RE: NHTSA Recall 08E-006, Hyundai Recall 081

TO: ALL HYUNDAI DEALERSHIP PARTS MANAGERS AND SERVICE MANAGERS:
SUBJECT: **Campaign 081 – Hitch-Mounted Bicycle Racks Sold During 2005 – 2007**

Group	CAMPAIGN
Number	08-01-003
Date	MARCH, 2008
Model	BIKE RACK

RECEIVER HITCH MOUNTED BICYCLE RACK (CAMPAIGN 081)

Without recall repair kit

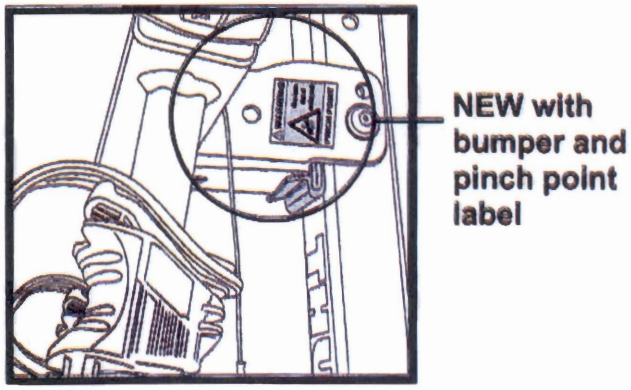
In cooperation with the National Highway Traffic Safety Administration, Hyundai Motor America is recalling all aftermarket Expressway 996 (P/N 00285-03000) and Expressway 995 (P/N 00285-03001) hitch mounted bike racks supplied by Thule and sold during the 2005 – 2007 period. Thule has determined and has notified Hyundai Motor America that a pinch point exists between the bike arm bracket and the upright assembly, which has the potential of causing a severe laceration or amputation to the user's fingertips or hand when the bike arm bracket is moved to it's "down" position. In December, 2007, Hyundai Motor America ceased distribution of Thule manufactured Hitch Mounted Bicycle Racks sold under the Part Numbers 00285-03000 and 00285-03001 during 2005 through 2007. HMA has also issued a Technical Service Bulletin related to this matter, 08-01-003.

Enclosed with this letter are two Point of Sale posters and two acrylic poster stands that contain important **SAFETY RECALL NOTICE** information for your customers, who may have purchased these bike racks from your dealership. Please prominently display these posters in your dealership where they can be readily seen by affected customers. *It is important that customers be aware of the pinch point hazard* and how to have it corrected.

PARTS AFFECTED:

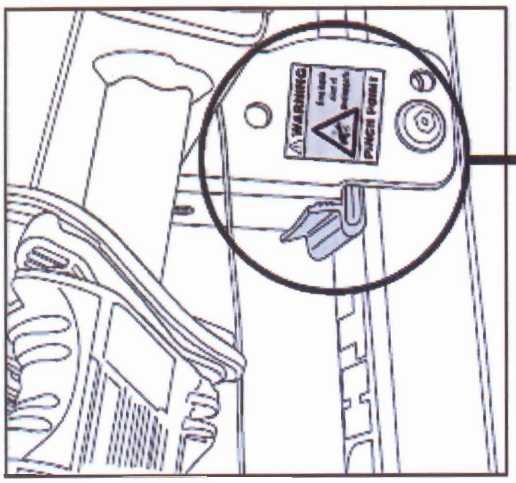
Thule, Inc. manufactured Expressway 995 and 996 receiver hitch mounted bicycle racks that were sold under the Hyundai brand during the 2005-2007 time period are being recalled because a pinch point exists between the bike arm bracket and the upright assembly. This condition has the potential to cause severe personal injury, including laceration or amputations to the user's fingertips or hand when the bike arm bracket is moved to its down position. Because this could happen without warning, owners **must stop using the rack immediately**. At all times, hands and fingers must be kept away from the area between the bike arm bracket and the upright assembly.

A free repair kit is available that will allow you or your customer to correct this condition by inserting a bumper at the pinch point location and adding a warning label. To obtain the kit, please call Thule at 1-800-THULE 91 (800-848-5391), provide them with your name and address, and follow the instructions to install the additional parts. You can also visit **http://www.thuleracks.com** for more information. If customers have incurred any cost for remedies in advance of this notification, please contact the toll free number listed above for information regarding reimbursement. Supporting documentation will be requested by Thule.

Without recall repair kit

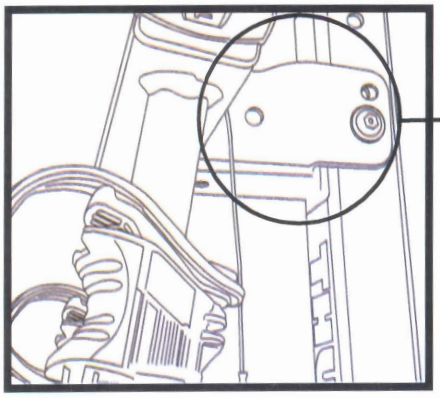
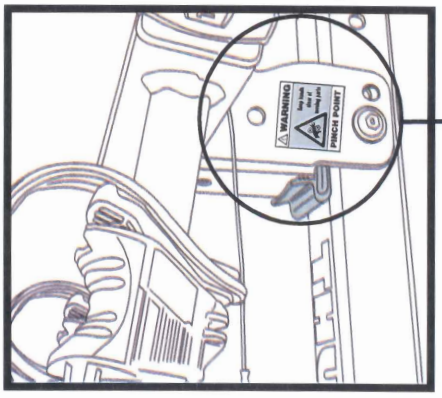
In cooperation with the National Highway Traffic Safety Administration, Hyundai Motor America of Fountain Valley, California is recalling all aftermarket Expressway 996 (P/N 00285-03000) and Expressway 995 (P/N 00285-03001) hitch mounted bike racks supplied by Thule and sold during the 2005 – 2007 period. Thule has determined and has notified Hyundai Motor America that a pinch point exists between the bike arm bracket and the upright assembly, which has the potential of causing a severe laceration or amputation to the user's fingertips or hand when the bike arm bracket is moved to it's "down" position.

NEW with bumper and pinch point label
